County of Loudoun
Office of Transportation Services
MEMORANDUM

SUBJECT: ZMAP 2006-0011, ZCPA 2006-0003—Stone Ridge Commercial
Third Referral

Background

Figure 7
 Future Proposed Lane Use and Traffic Control and
 Peak Hour Levels of Service

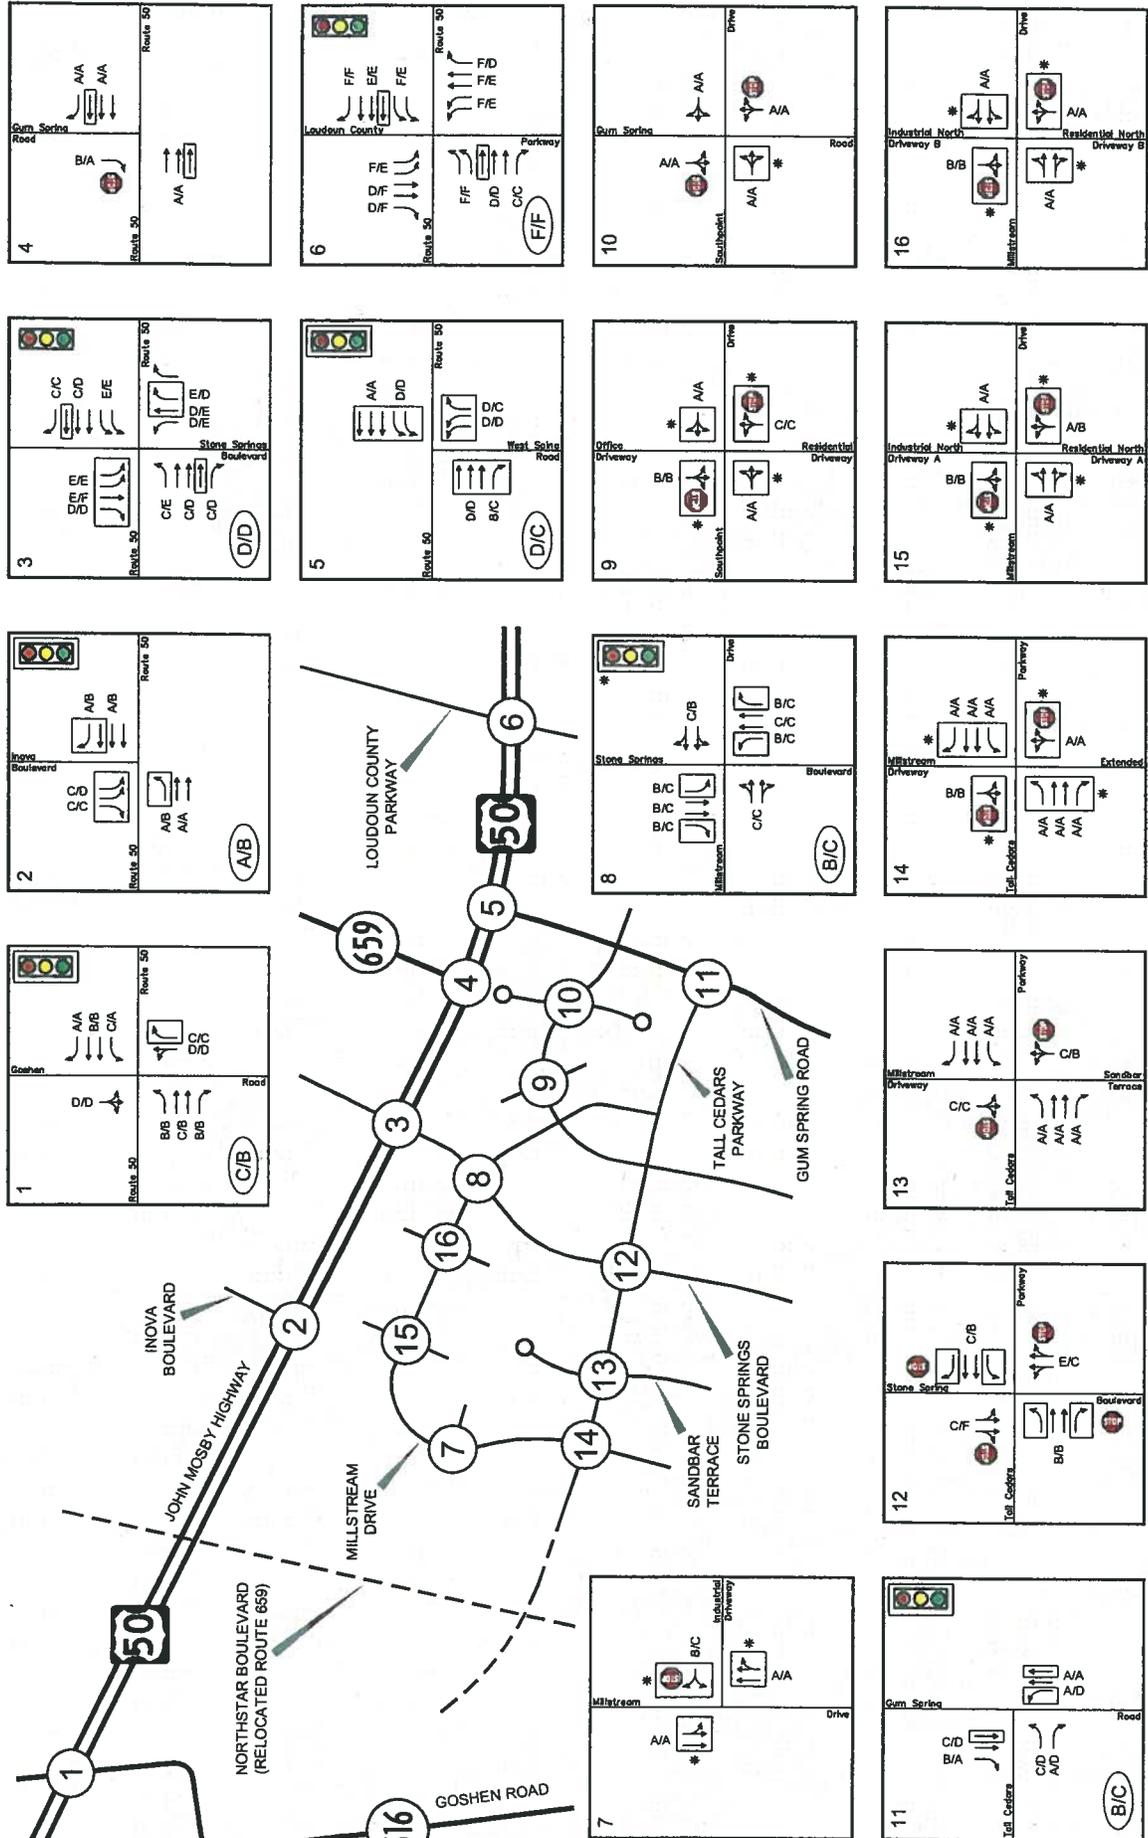
10. Initial Staff Comment (2nd Referral, April 17, 2009): The Applicant should commit to implement/construct the on-site "proffered" and "site" improvements identified in the updated traffic study for the proposed development program (see *Attachment 10 [in the 2nd OTS Referral]*). The study indicates that these improvements are necessary to realize the forecasted peak hour intersection LOS conditions presented.

Current Issue Status: The current and/or previous proffer statements for Stone Ridge contain specific commitments for many of the on-site "proffered" and "site" improvements shown in *Attachment 10* of the traffic study. However, two items do not appear to be addressed, namely (1) a commitment to construct an additional lane on northbound Stone Springs Boulevard at Route 50 (Intersection 3) (the traffic study assumes a total of four lanes (one left, one through, and two right), but only three lanes (one left and two right) are currently constructed), and (2) a commitment to construct necessary improvements at the future intersection of Stone Springs Boulevard at Gum Spring Road (Intersection 10) (turn lanes and signalization) at the time the connection is made; this is particularly relevant if the connection is made while Gum Spring Road is still open to through traffic (see Comment #2 above). OTS recommends that such commitments be included in the current proffer statement.

Applicant's Response (June 16, 2009): *The proffers for the proposed development program commit to implementing/constructing both the "proffered" and "site" improvements.*
